**AMENDMENTS TO THE DRAWINGS**

**REMARKS**

This paper is filed in response to the Office Action mailed 23 May 2005. Claims 1-20 were pending in the application. Claims 1, 3, 5 and 11 have been amended. Claim 2 has been canceled. Claims 21 – 39 have been added. Therefore, claims 1, 3 – 39 are now pending in the application and are submitted for reconsideration.

FIG. 1

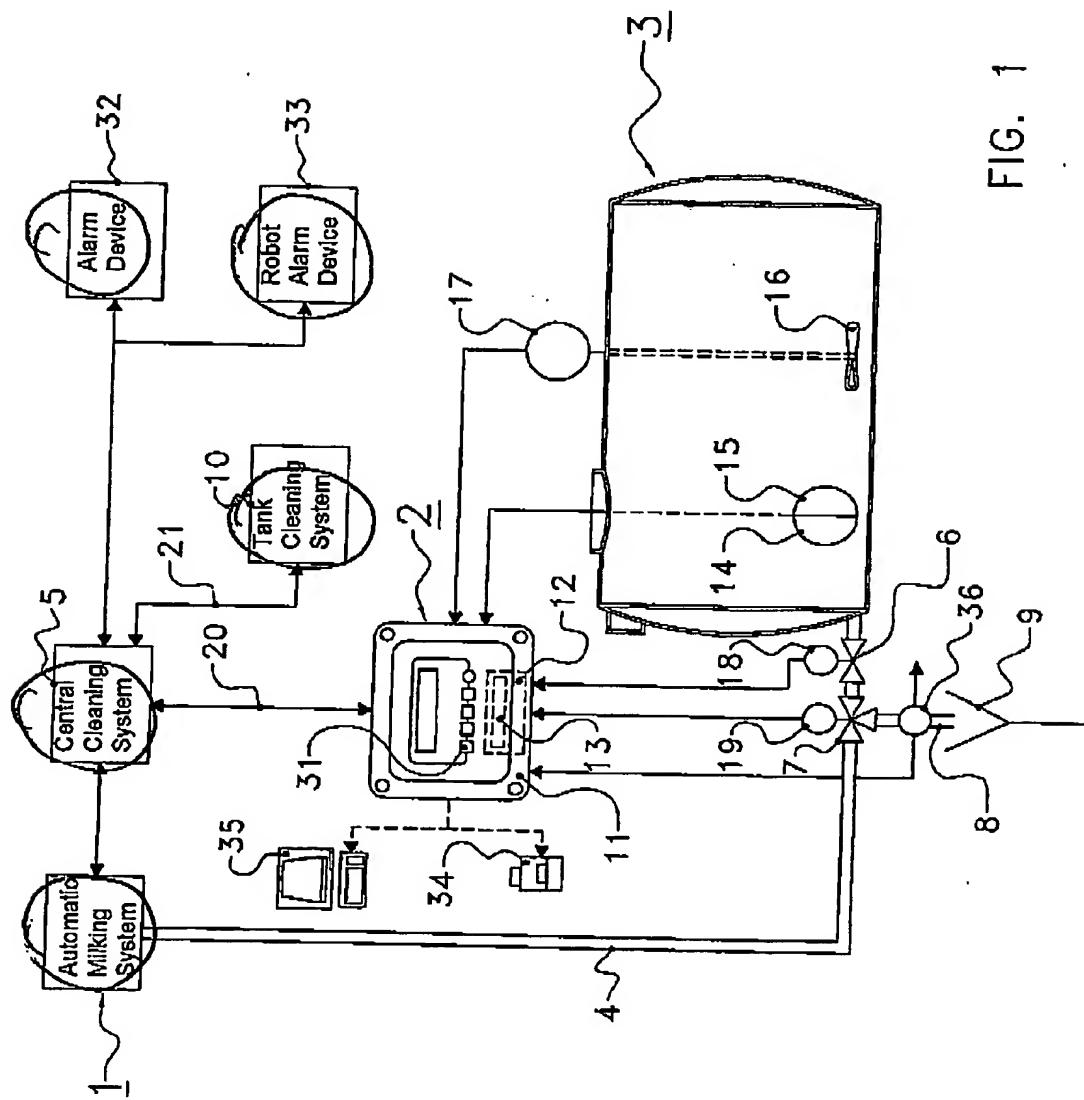
Figures 1 and 2 were objected to because they failed to contain appropriate legends. An amended version of Figures 1 and 2 is attached as described above. The legends used correspond to the designation as described by the respective reference numeral within the body of the description. No further subject matter is added by such amendments.

Amended drawing pages 1/7 and 2/7 are presented with this paper. Specifically Figures 1 and 2 have been amended to include legends as required by the Examiner under Item 3 of the office action.
